Project Name & Address: 302 Lathrop Street

Application Type(s): Certificate of Appropriateness for new construction in the University Heights historic district

Prepared By: Heather Bailey, Preservation Planner, Planning Division

Date Prepared: October 27, 2020

Staff proposed alternative garage door design

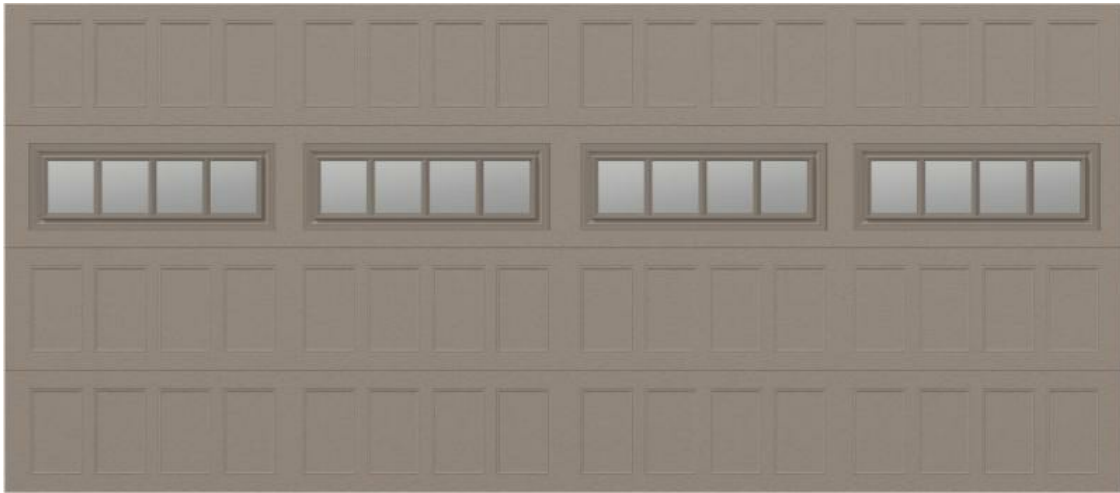
1. Submittal of new garage vehicle door that is in keeping with the style of doors found on similar garages within 200 feet, to be approved by staff
2. Submittal of new window specifications for simple one-over-one windows, to be approved by staff
3. Submittal of drawings of the proposed new rear entry or pictures of the current rear entry configuration for approval by staff due to the unapproved removal of the nonhistoric rear deck
